NR-COGEN-CM  
Construction Management Services for North River  
Cogeneration and Electrification  
AECOM  
125 Broad St., 16<sup>th</sup> Floor  
New York, NY 10004  
T 212.377.8693

Subject: AIS Availability Waiver Request (10" and 12" Globe Valves)  
New York City Department of Environmental Protection  
North River WWTP, WP-164  
Contract NR-38, Cogeneration and Electrification  
Registration No. 20171426056  
SRF Project No. C2-5234-28-00

May 15, 2018  
No. NR-38-AECOM-009

Re: New York City Department of Environmental Protection (NYC DEP)  
WP-164, North River WWTP Cogeneration and Electrification  
Contract NR-38  
Manual Globe Valves - AIS Waiver Request

DATE: 8/26/16  
SCALE: NONE  
SHEET NO:  
37 OF 1176  
DRAWING NO.  
G00-6030

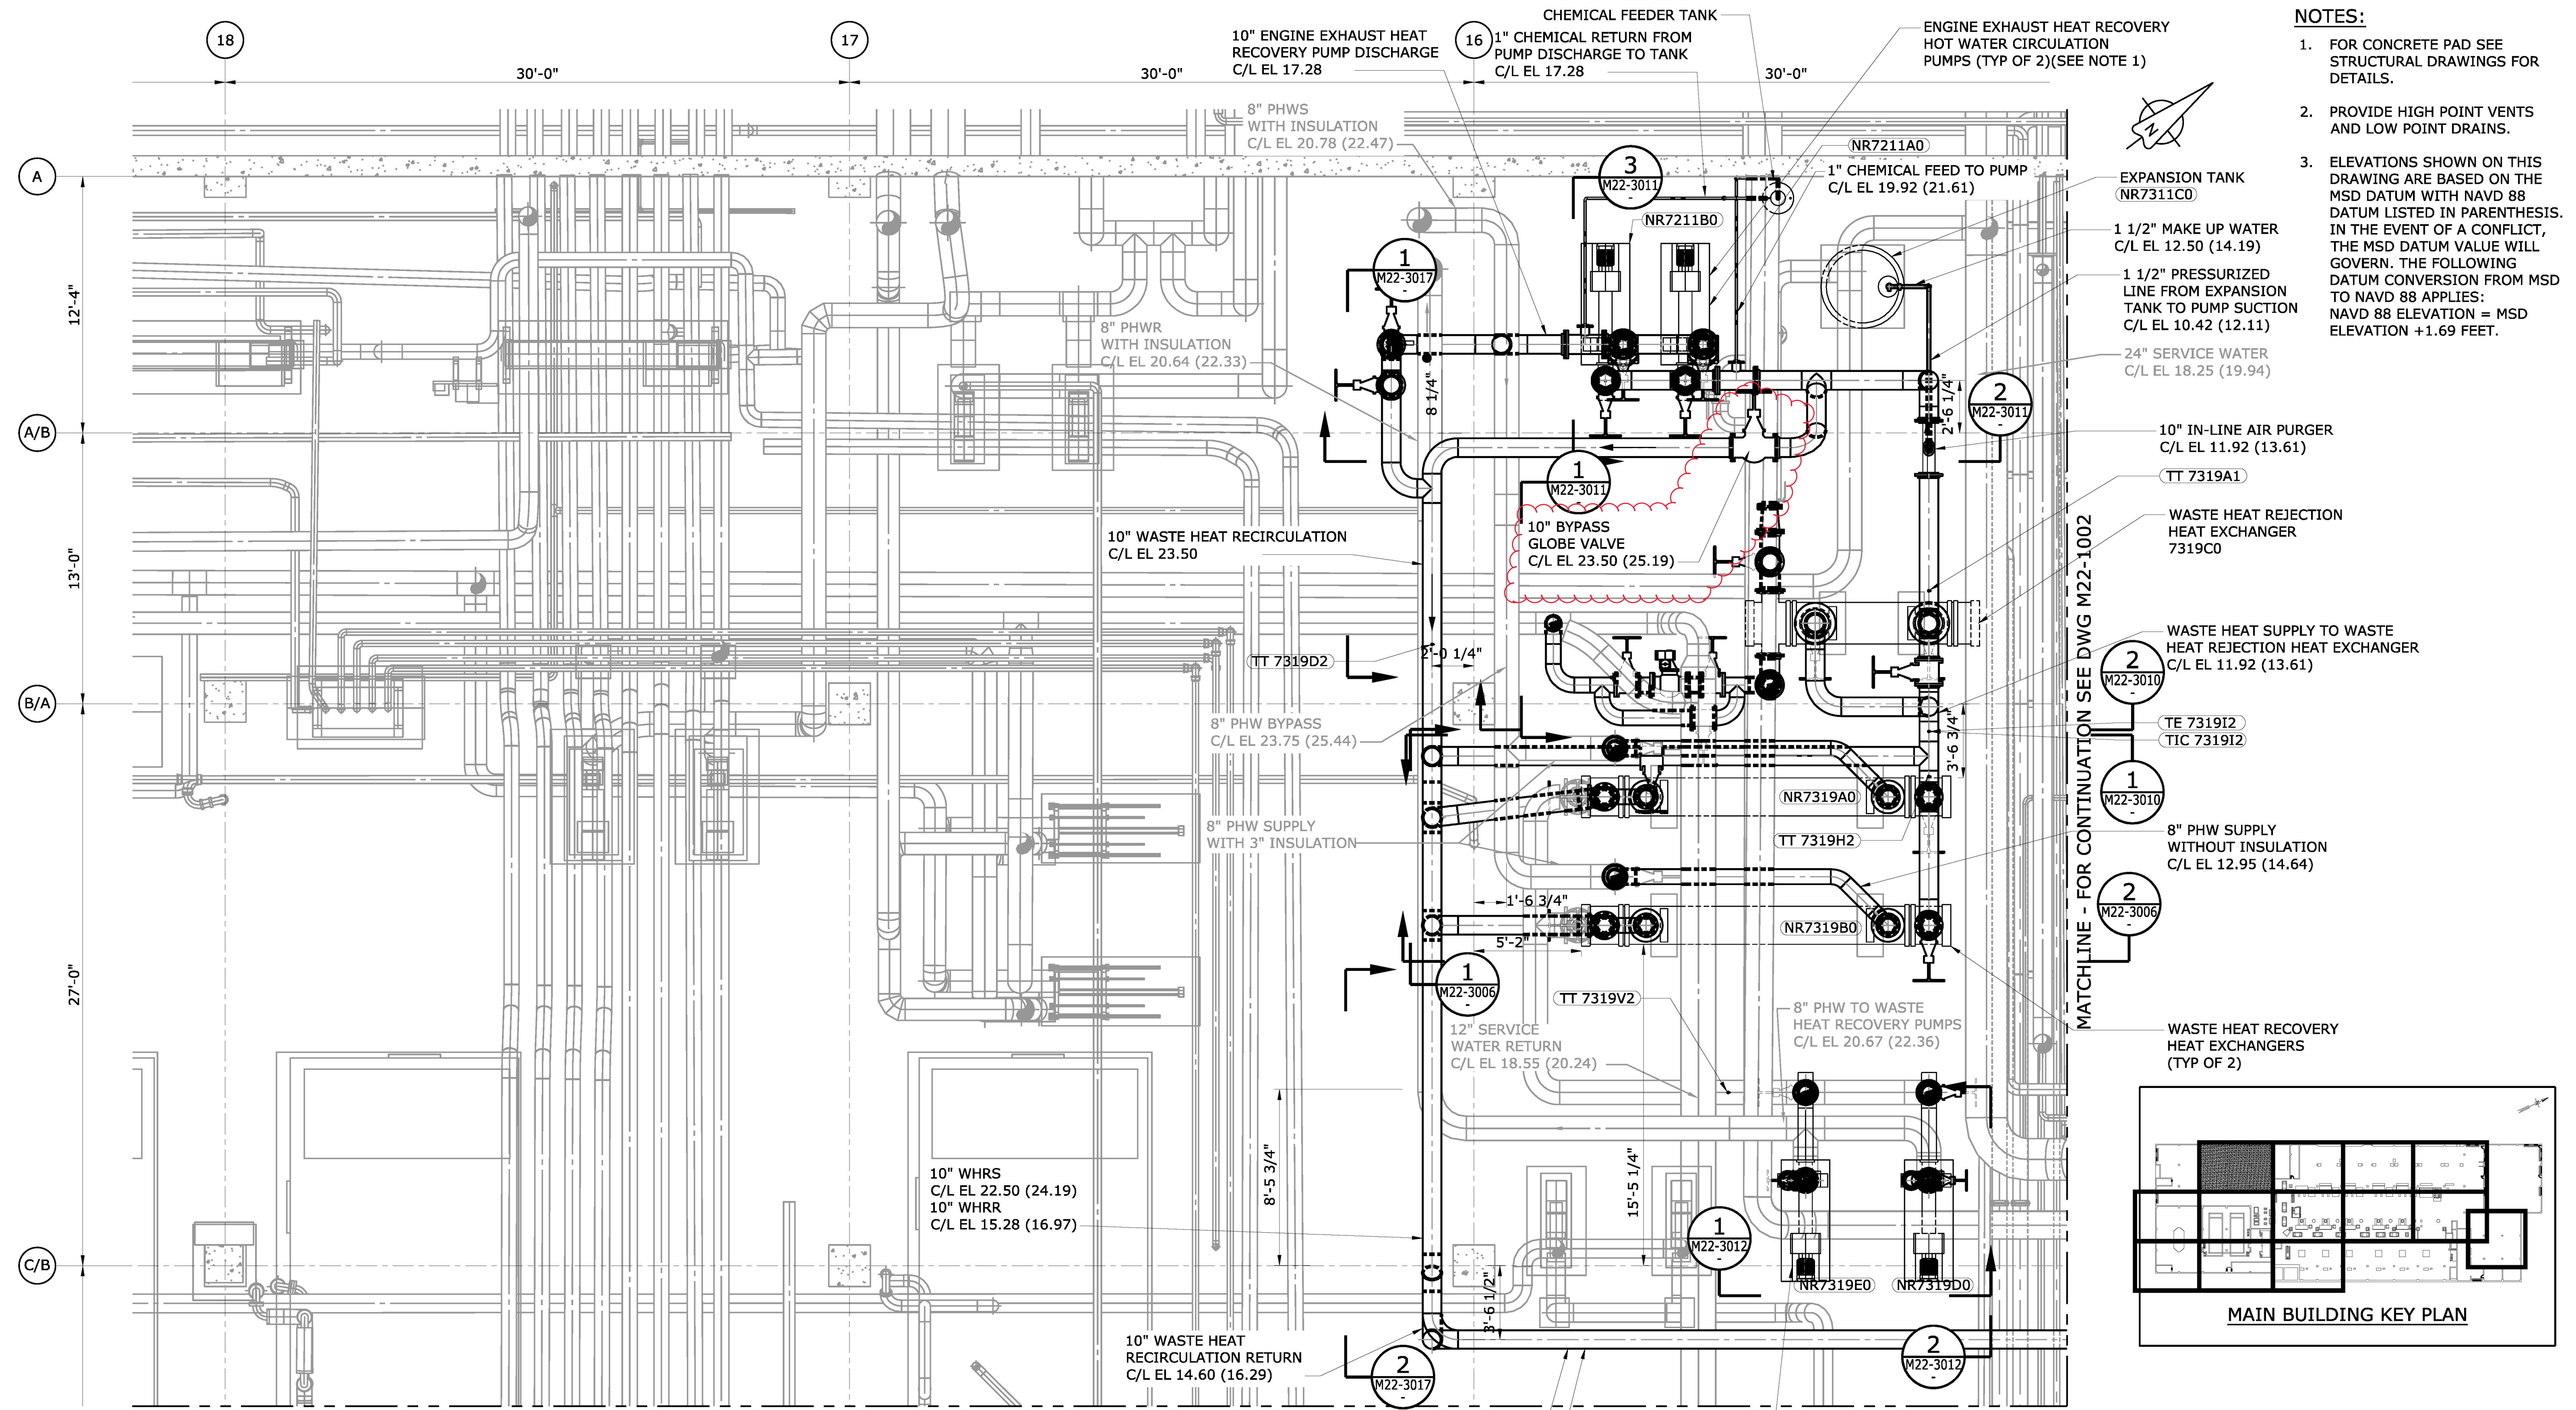
Under this Contract NR-38 with NYC DEP, Yonkers Contracting Company, Inc. (YCC) is required to furnish and install One (1) -10" Manual Globe Valve and One (1) -12" Manual Globe Valve for water service of the cogeneration engine exhaust heat recovery and cooling heat rejection systems in accordance with the Contract detailed specification 15111G "Valves – 4 inches and Larger" and as shown in the Contract Drawings G00-6029, G00-6030, M22-1001 and M22-1004.

10" Manual  
Globe Valve
